**Item 6.****Development Application: 265-273 George Street, Sydney - D/2024/367**

File No.: D/2024/367

**Summary**

Figure 28: Unifying datum diagram of the original proposal

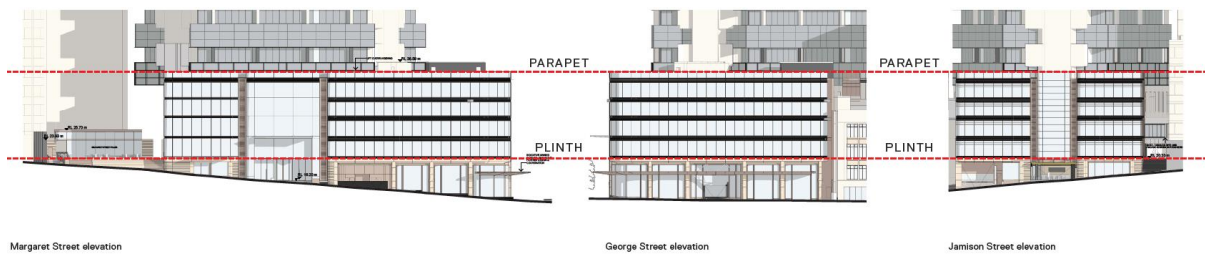
Recommendations	Response
<p>More solidity in the proposed podium facade would reinforce the street wall and provide a better contextual response. Increasing the proportion of masonry (stone) in the podium facade would create a better contextual fit, which would also create opportunities for better integration with the existing tower, by referencing the tower's horizontal elements into the podium design for example.</p>	<p>The proposed development has been amended to increase the thickness of, and incorporate masonry elements into, the spandrels of the curtainwall facade to increase the solidity and masonry character of the facade.</p> <p>Consistent with the Panel's assessment, the curtainwall facade continues to have a strong horizontal emphasis as a contextual response to the heritage-listed former Telford Trust Building at 261 George Street and the existing triangular tower behind, as illustrated below:</p>

Recommendations	Response
	 <p><b>Figure 27:</b> Horizontal expression diagram</p>
<p>The proposed podium height does not align with the dominant street wall height set by the former Telford Trust Building at 261 George Street. It appears that the proposed podium height has been set to not obscure views from the tower behind. Nevertheless, it would be good to express the street wall in some way.</p>	<p>The podium height was proposed as a unifying datum for the site, and was indeed set originally to avoid obscuring views from the existing tower behind (Figures 28 and 29).</p> <p>The parapet height of the former Telford Trust Building is also some 5.8m above the proposed podium height. As such, it is difficult to fully express the parapet height of the former Telford Trust Building without compromising the integrity of the proposed podium design.</p> <p>Notwithstanding, a pavilion addition that is setback from the podium's curtainwall facade is added to express a taller height datum as a response to the parapet height of the former Telford Trust Building while preserving the proposed podium height and the unifying datum that is presents. This is considered to be a sensitive and acceptable response.</p>

Figure 29: Diagrammatic section comparison of the George Street and Margaret Street podium design, original proposal on the left and amended proposal on the right

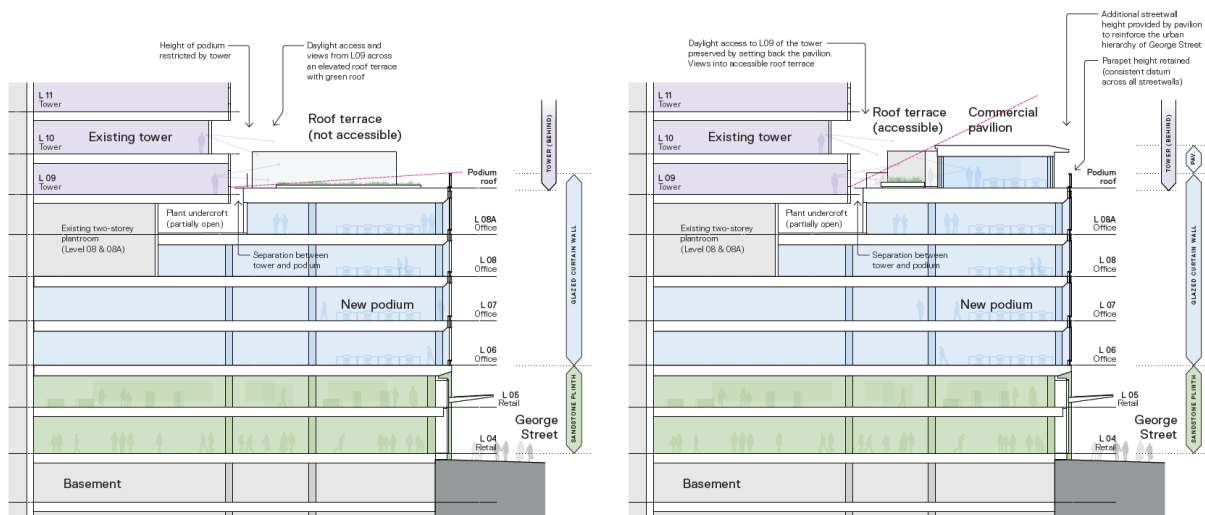
- (a) amend the design of the Margaret Street and George Street corner to better respond to the street wall height of the former Telford Trust Building at 261 George Street, and to provide greater solidity to the podium facade to better respond to the more solid street walls in the immediate surrounds;
